TITLE: Sound Card (65816)	REV: 1.1
Company:	Sheet: 1/1
Date: 2022 April 21 Drawn By: rehsd

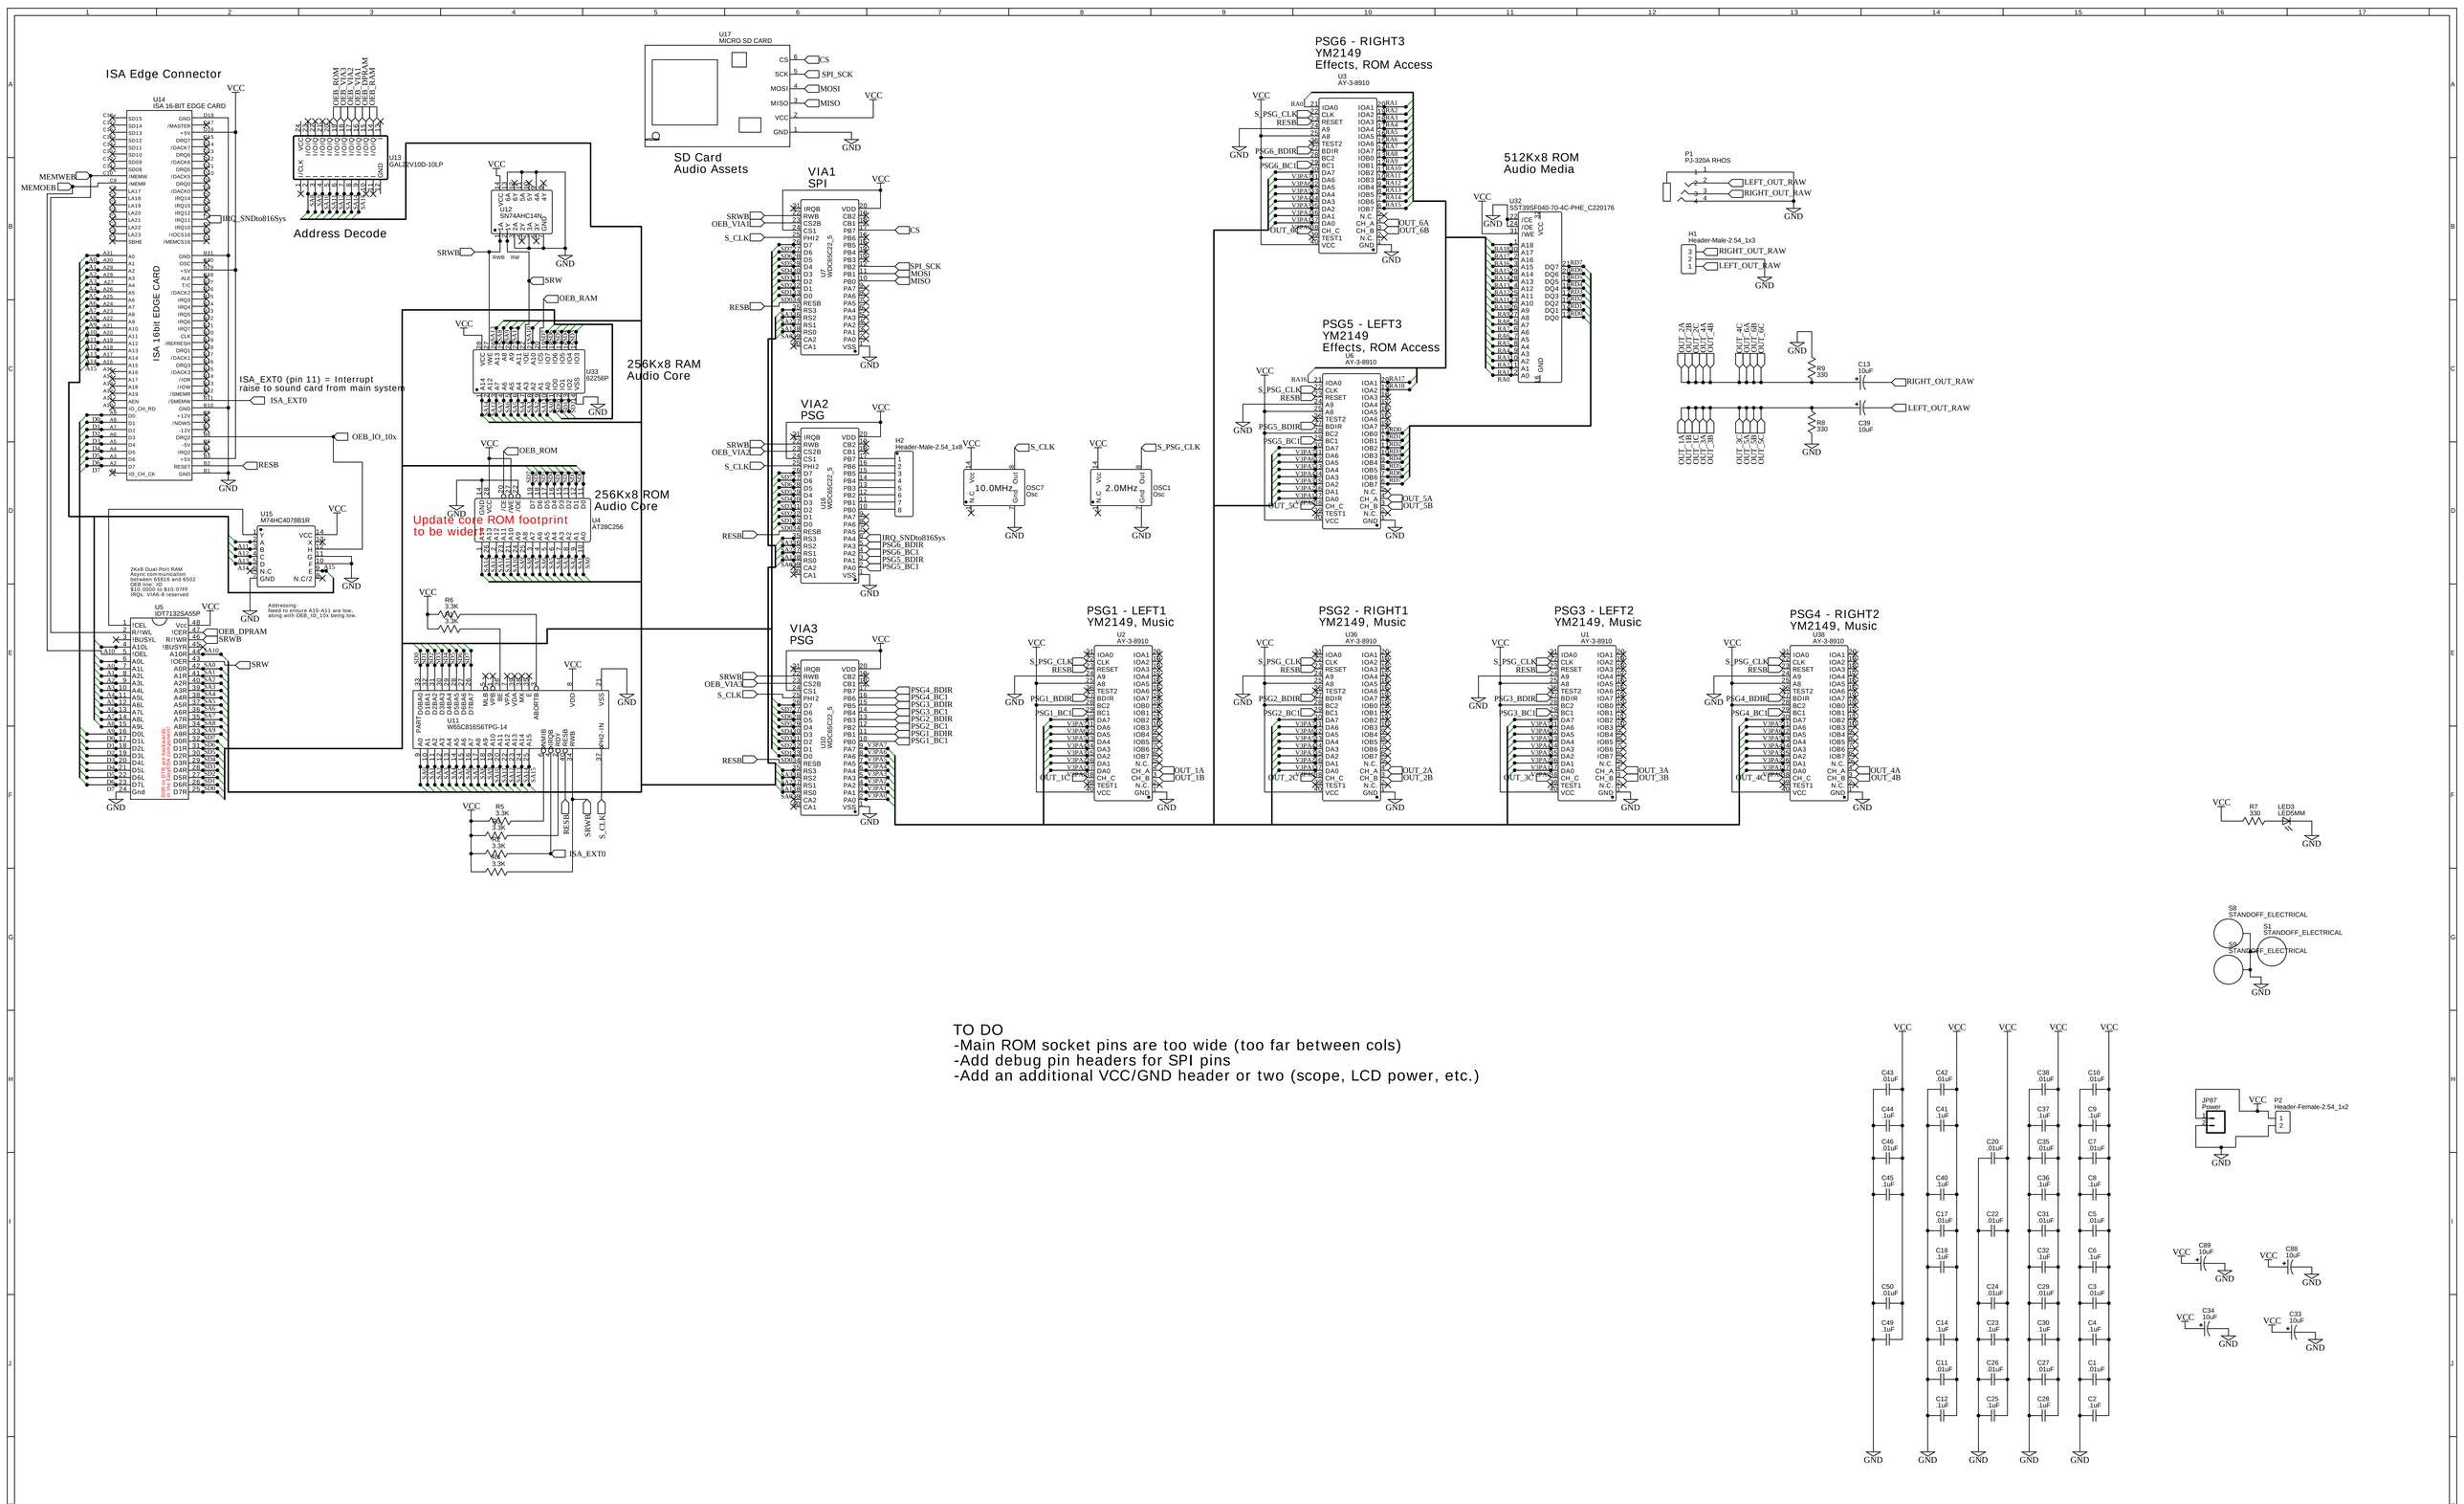
TO DO
-Main ROM socket pins are too wide (too far between cols)
-Add debug pin headers for SPI pins
-Add an additional VCC/GND header or two (scope, LCD power, etc.)
